Link Training Timer Update for D2.1

(comments # 66, 418)

Figure 178B-10—Training control state diagram

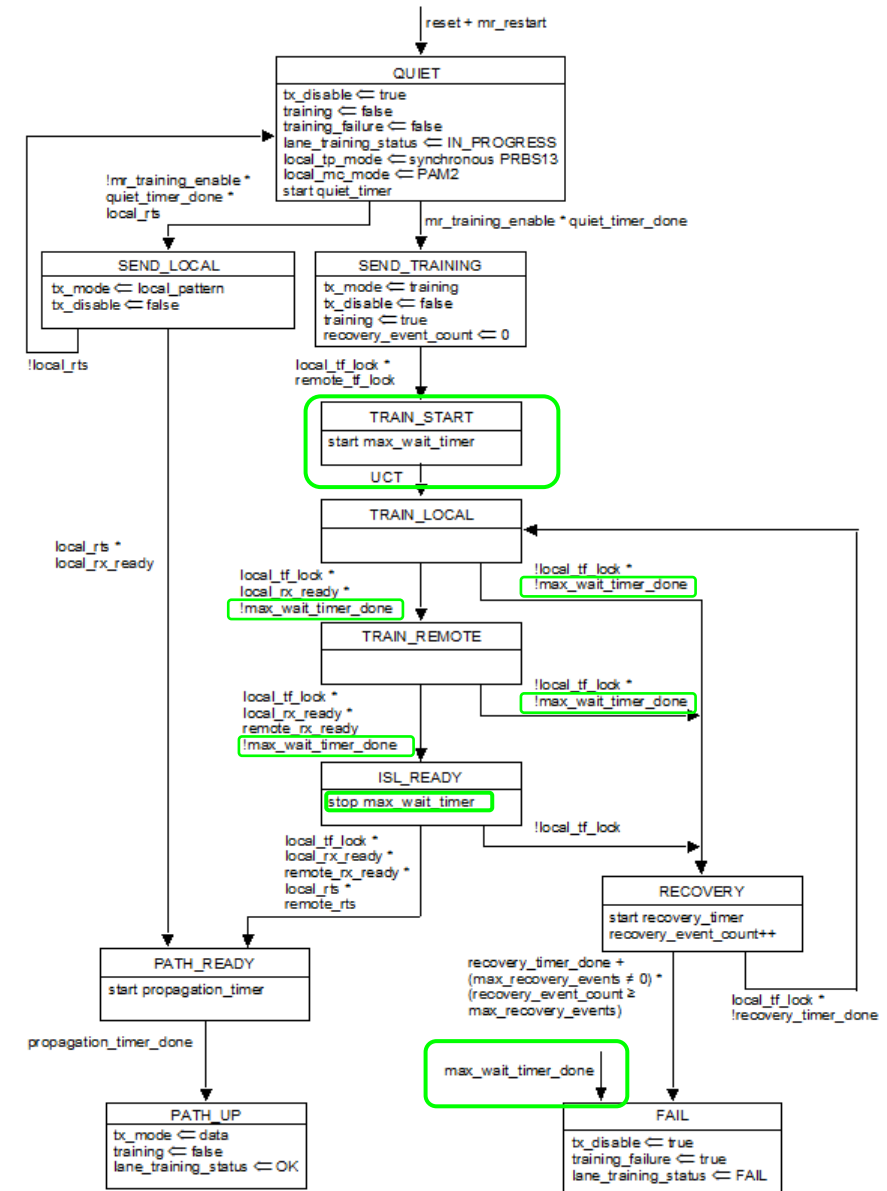
- Additions to the original diagram are highlighted in green.
- The new timer is started in new state TRAIN_START.
- The timer is active during TRAIN_LOCAL and TRAIN_REMOTE, and stopped in ISL_READY.
- Expiry before it is stopped causes transition to FAIL.
